LINE	QUANTITY	UOP	CAT NO	ITEM NUMBER	UNIT PRICE	AMOUNT
ADDENDUM #01						
THIS ADDENDUM IS ISSUED TO MODIFY, CLARIFY, ADD TO, AND/OR DELETE REQUIREMENTS OF THE ORIGINAL SPECIFICATIONS.						
ATTACHMENTS: 1. ADDENDUM #01 2. DRAWINGS 3. PRE-BID SIGN-IN SHEET						
0001	1	LS		968-62		
PARKING LOT CONSTRUCTION						
***** THIS IS THE END OF RFQ DEFK8058 ***** TOTAL: _____

**WEST VIRGINIA ARMY
NATIONAL GUARD****ADDENDUM 1**

SUBJECT: CHP Facility Concrete Turning Pad
RFQ#: DEFK8058
DIV: Division of Engineering and Facilities
Date: 21 September 2007
Senior Buyer: Mr. John Abbott
Project Manager: CPT. Michael Beckner

CONCRETE TURNING PAD DETAIL (LAYOUT)
 NOT TO SCALE

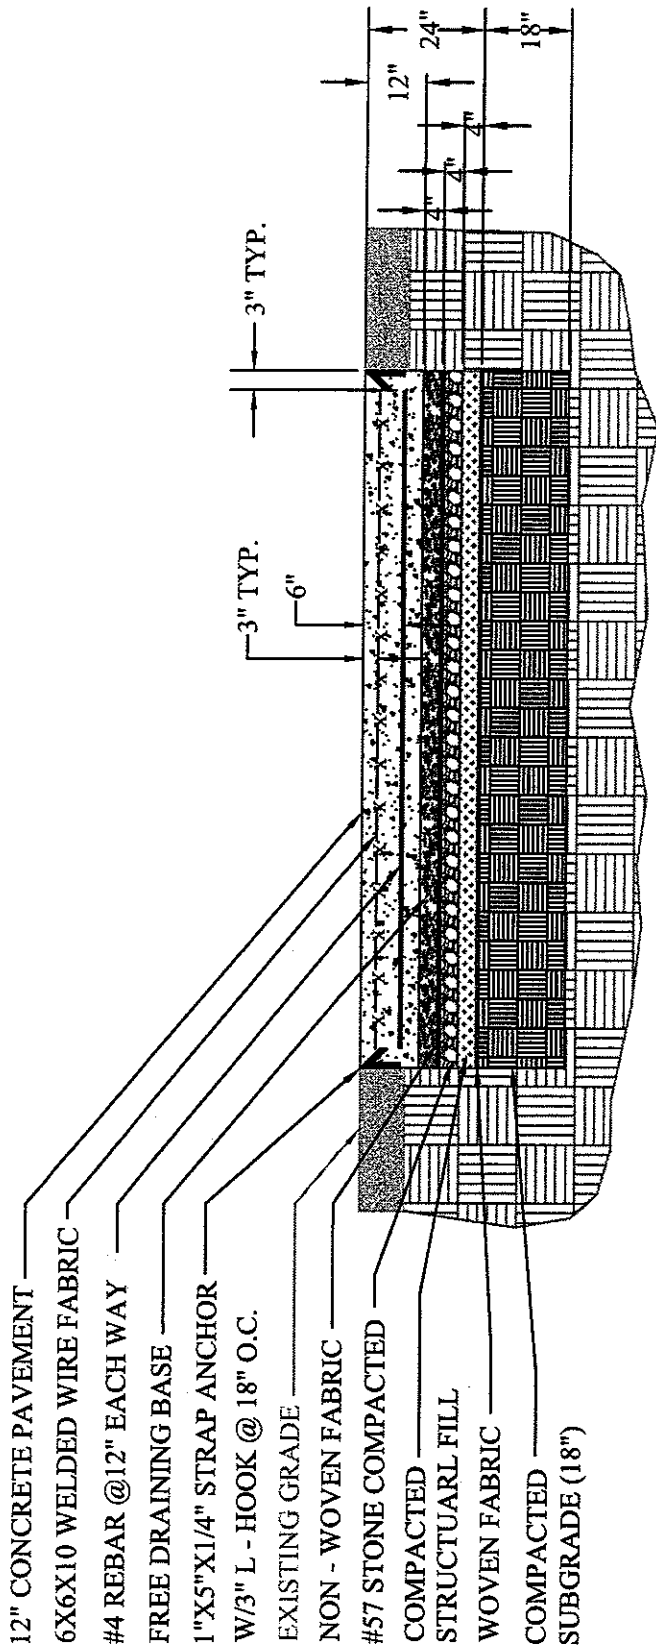
5. The over all dimensions for the concrete pad has been reduced from 100' X 100' to a 75' X 75'.
6. The expansion joint distance has been changed to 25' grid and score joint grid has been revised to 12 ½ ' grid blocks. (See attached revised layout drawing.)

7. The slope grading on the concrete pad has been revised to show the pad draining toward the fence and away from the building. (See attached revised layout drawing.)

8. The Concrete pad is to abut existing loading dock ramp. Contractor to saw cut an edge on ramp, and make the transition from the ramp to the new concrete pad. Contractor is to provide and install expansion joint between existing concrete ramp and new concrete pad. Load transfer dowels will not be installed at this connection. On the opposite side the pad will be abutting an existing level concrete loading dock pad. The contractor is required to install an expansion joint at this connection also, and again load transfer dowels shall not be installed at this location.

EXISTING CONCRETE RAMP
 MAKE SMOOTH TRANSITION TO
 NEW CONCRETE PAD
 EXPANSION JOINT ONLY.
 DO NOT INSTALL LOAD
 TRANSFER DOWELS AT
 EXISTING CONCRETE
 CONNECTION.

(ASSUME GRADE
 ELEVATION 99.00 FT.)
 MATCH EXISTING
 PAD ELEVATION
 SCORE CONCRETE IN
 12-1/2' X 12-1/2' GRID
 BOTH DIRECTIONS
 EXPANSION JOINTS SET
 AT 25' BOTH DIRECTIONS

STANDARD SHEET PVT4

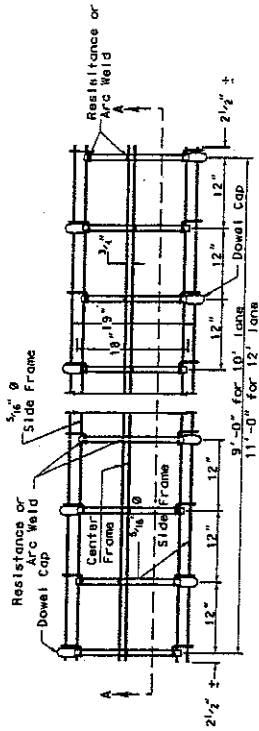
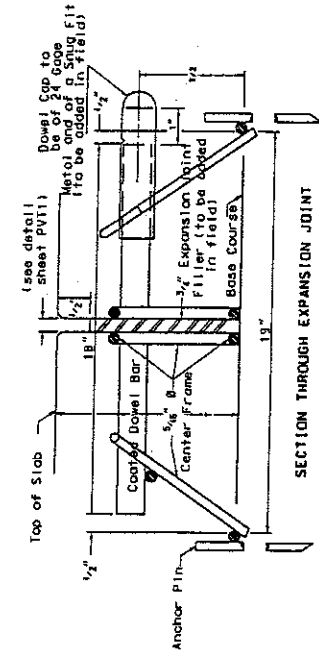
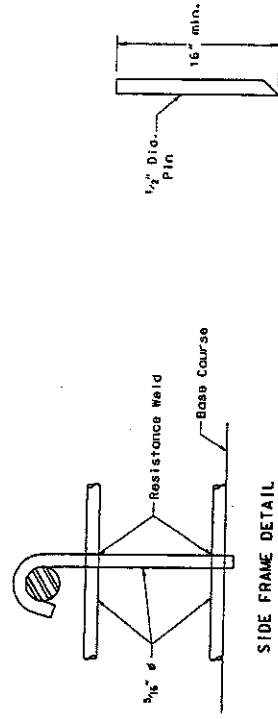
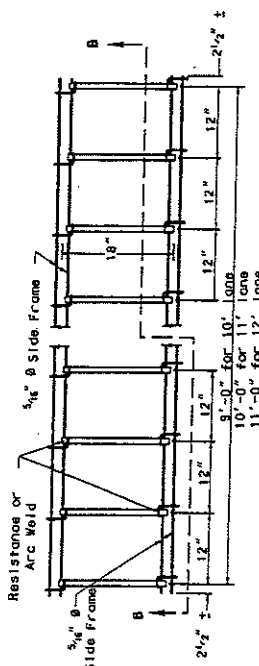
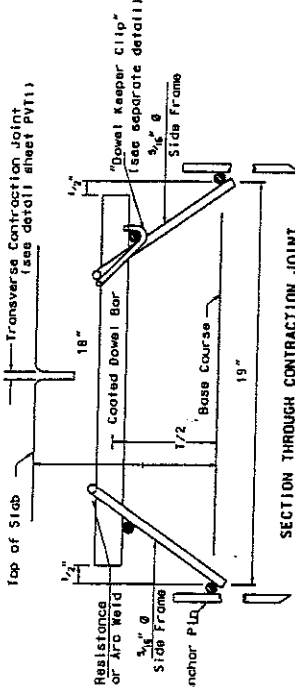
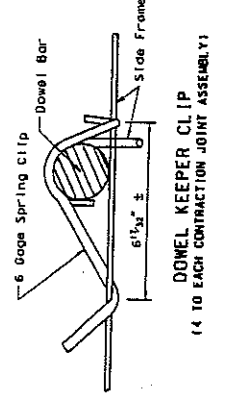
3. All joint sealant to also be performed per the West Virginia DOH specification on attached Standard Sheet PVT1.
4. Load Transfer Dowel bars are to be installed through expansion and contraction joints per the West Virginia DOH specification on attached Standard Sheet PVT4.
